CENTER FOR NUCLEAR WASTE REGULATORY ANALYSES 19/55

NONCONFORMANCE REPORT

NCR No. 2002-08

One of the Alloy 22 weld qualification specimens CNWRA Drawing 20-01402-571-025 machined by Texas Toolmakers was not machined correctly. A detailed description of the non conformance items is provided below:

Alloy 221 Specimen
CNWRA Drawing 20-01402-571-25
All Dimensions ± 0.010 "
unless otherwise specified
Note: Detail A on Page 2

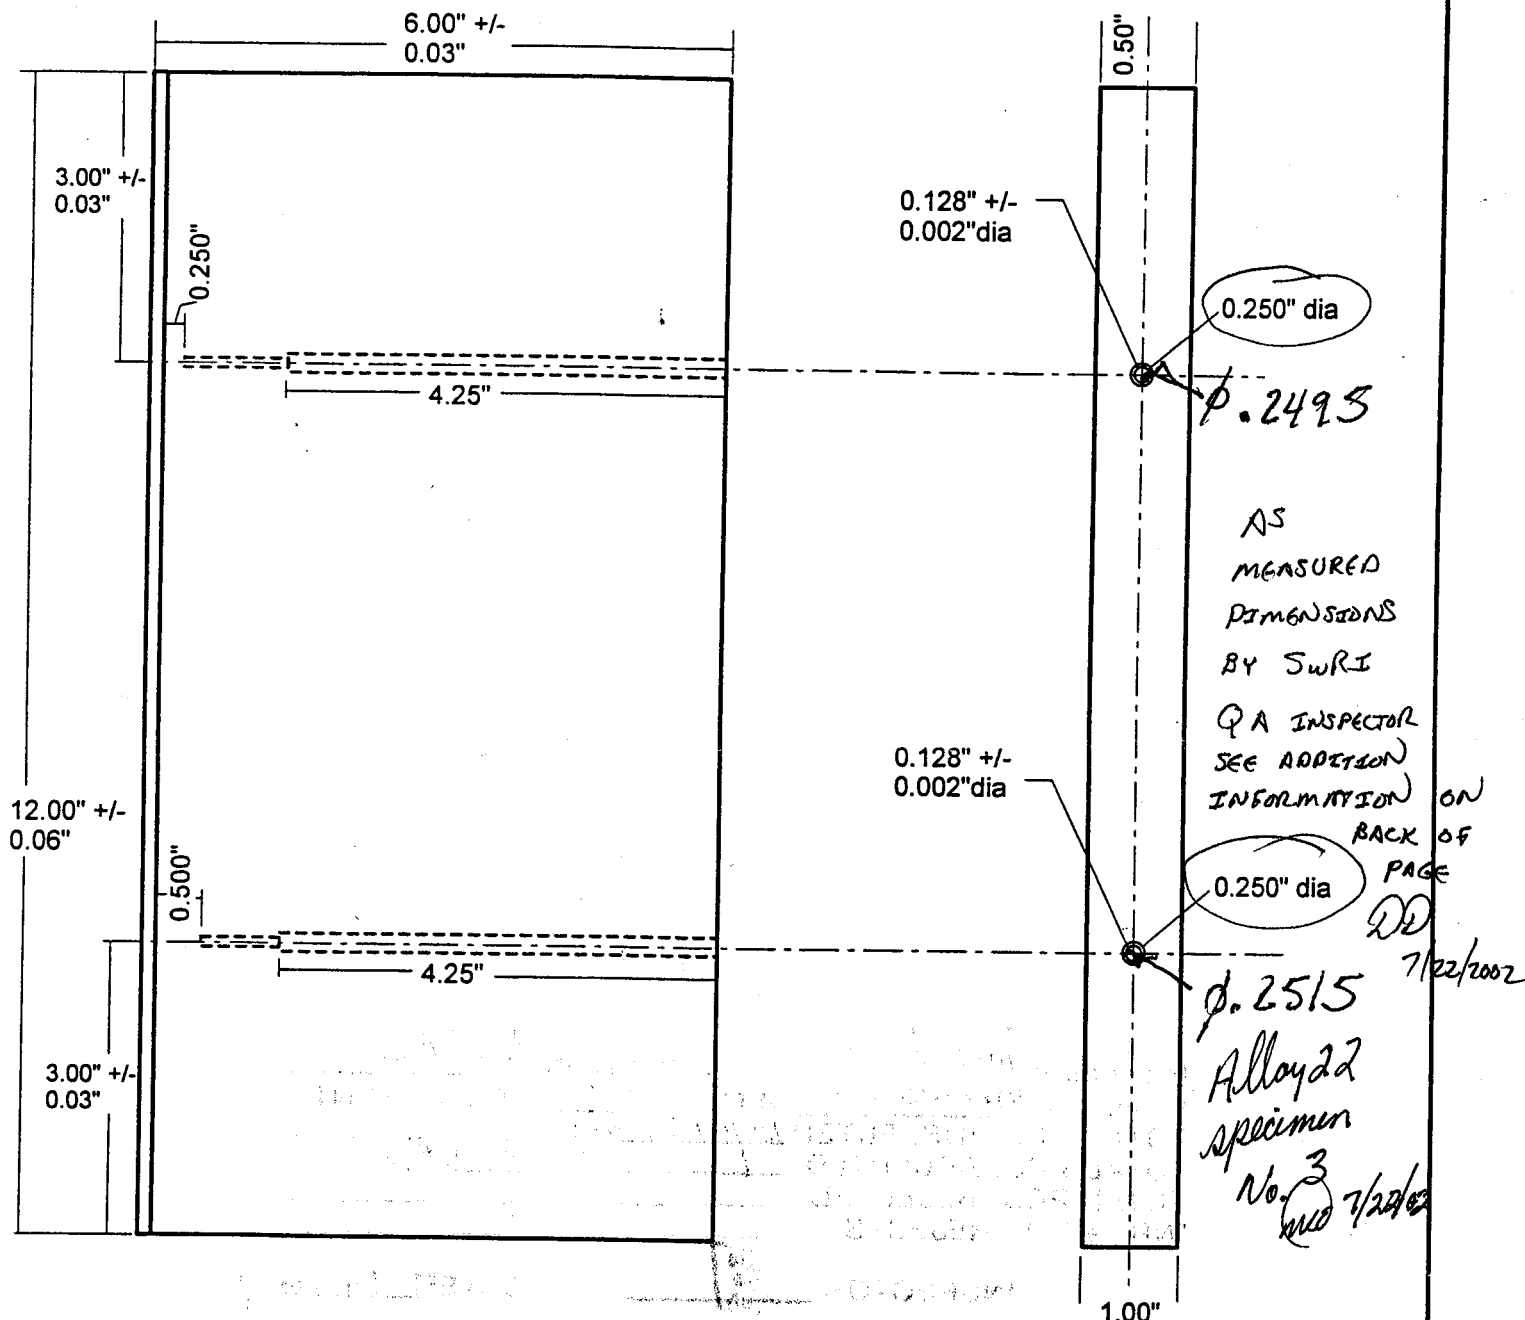
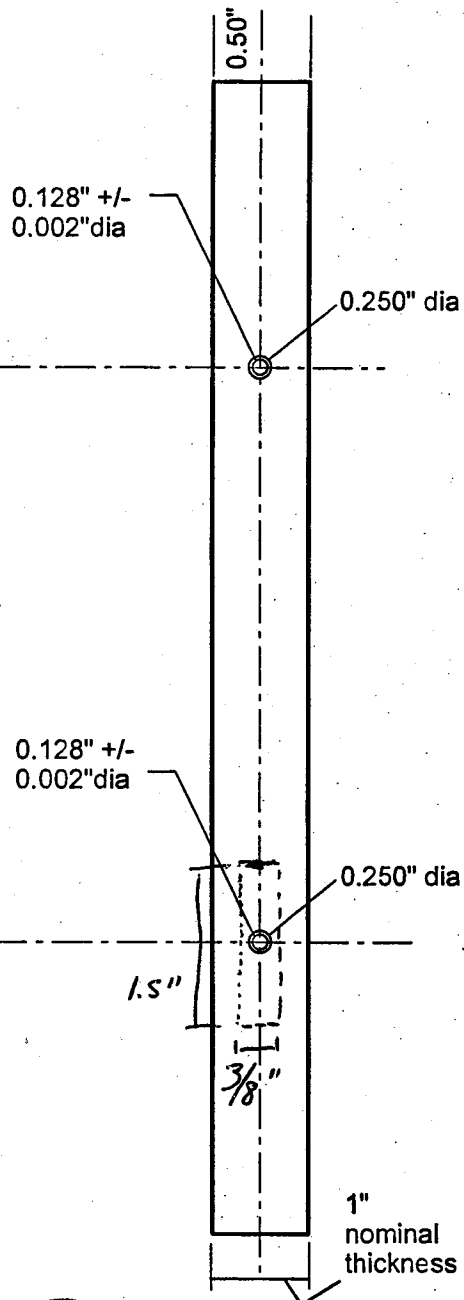
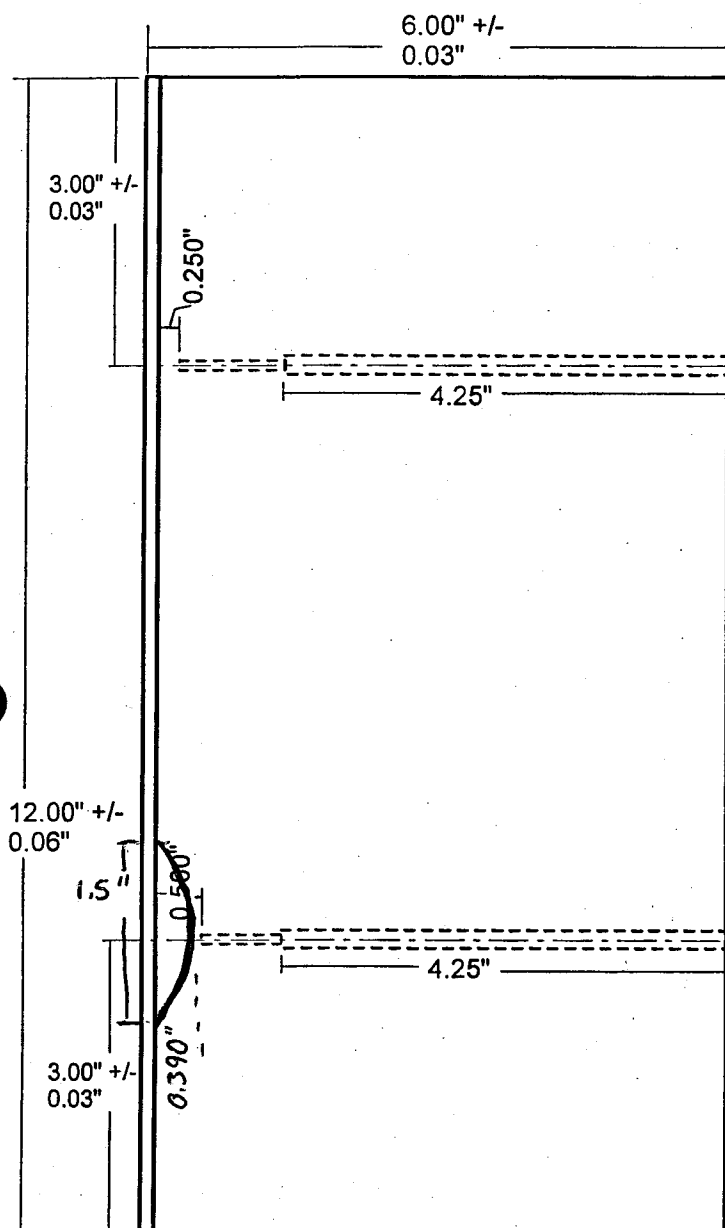
1. All plates: The 1.00 inch dimension (plate thickness) was not machined. Thickness of machined specimens was left as the nominal plate thickness.
2. Plate S/N 003: The 0.250 inch dimension was not recorded on the dimensional inspection for plate S/N 003.
3. Plate S/N 006: Thermocouple bore was machined too deep and has nearly penetrated through the weld joint surface.

Item #1: Plate thickness is not normally not machined for this type of specimen. Corrections to CNWRA Drawing 20-01402-571-25 are recommended. The 1.00 +/- 0.010 inch dimension for plate thickness should be changed to 1 inch nominal thickness.

<p><i>Item 1 - Drawing 20-1402-571-25 has been revised to reflect a 1" nominal thickness.</i></p> <p>PART 4: CLOSE OUT:</p> <p><i>Comments: Item #2 - Hole diameters were measured and found acceptable. Item #3 - Specimen 06 will not be used to qualify a welding procedure and will not be used for testing purposes. Ref Memo D. Dunn to B. Malita 3/24/03</i></p> <p>Verified by: <i>Mark R. Ehnstom</i> Date: <i>3/24/03</i></p>	<p>Distribution:</p> <p><i>20/55</i></p>
--	---

Item No. 2 on the NCR, examination of a 0.250-inch hole, has been performed and is acceptable. Item No. 1, drawing revision has not been performed but is not a quality-affecting hold point for close out of NCR 2002-08.

Alloy 22 Weld Specimen
CNWRA Drawing 20-01402-571-25
All Dimensions ± 0.005 "
unless otherwise specified
Detail A identified on Page 1

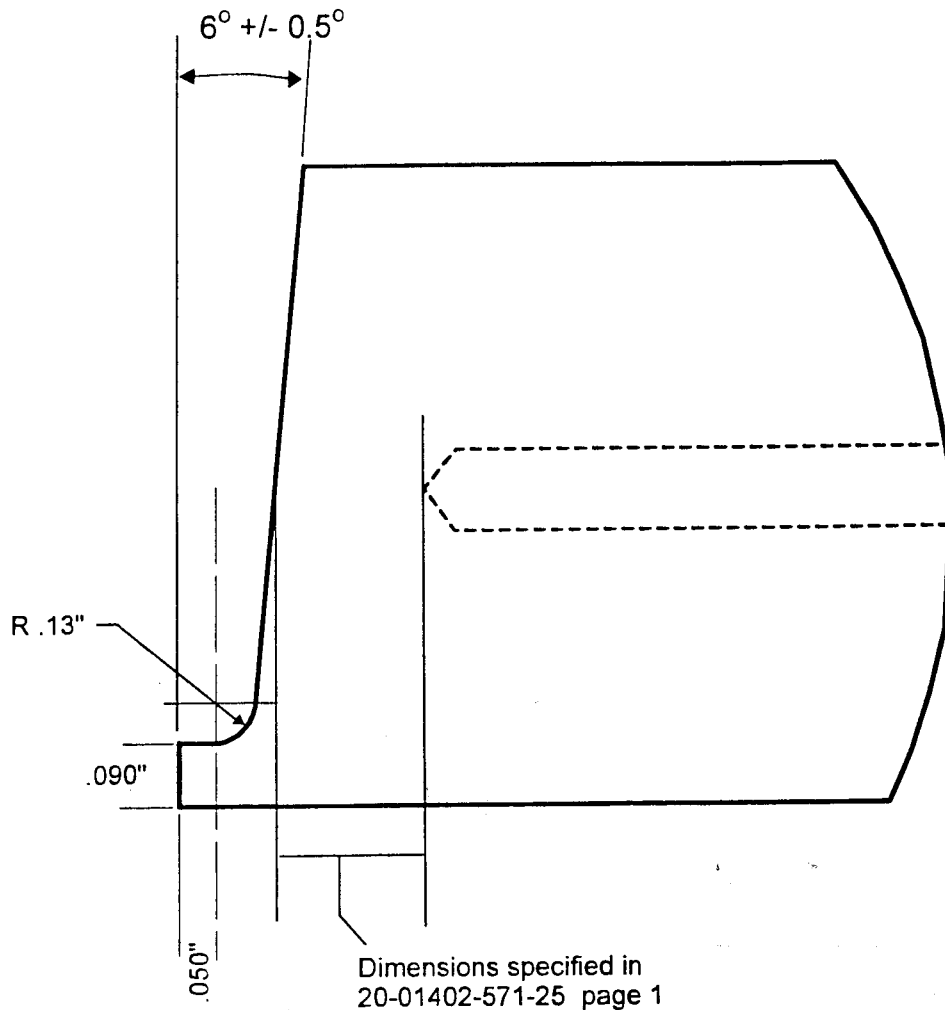
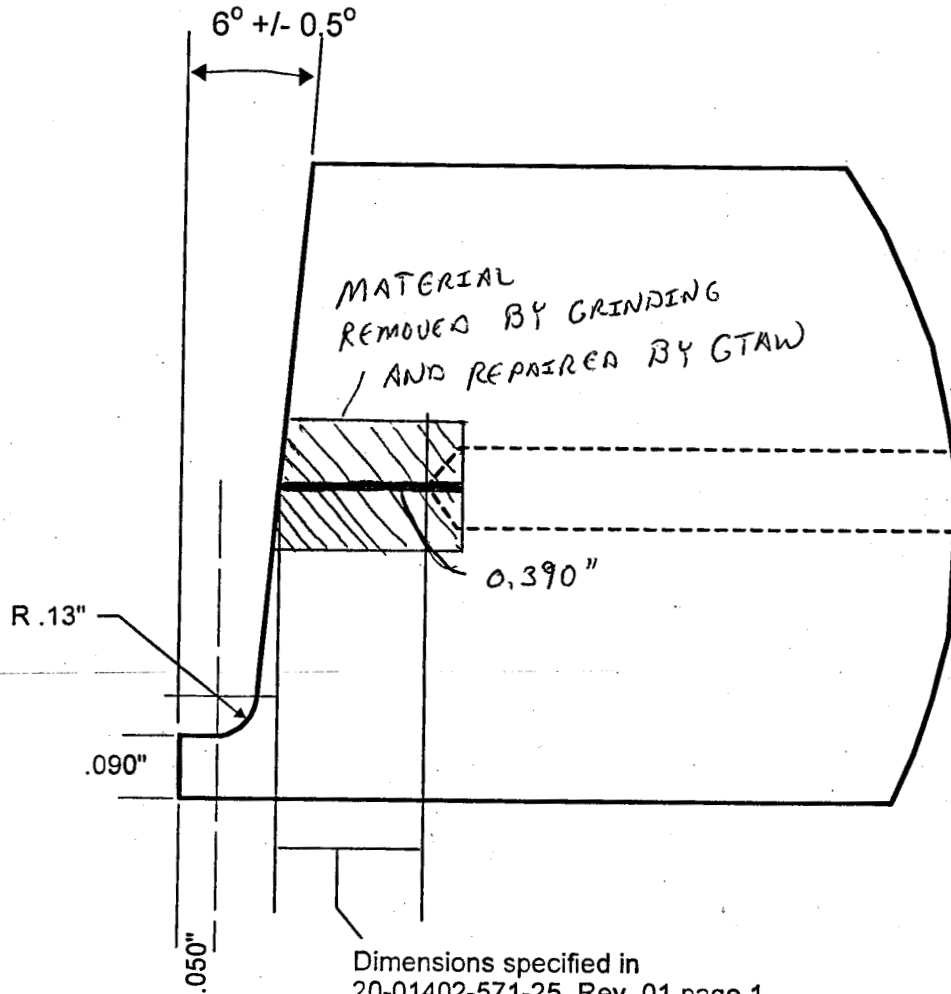
Item #2: The 0.250" hole diameter will be verified by SwRI staff and documented on dimensional inspection for Plate S/N. 003.
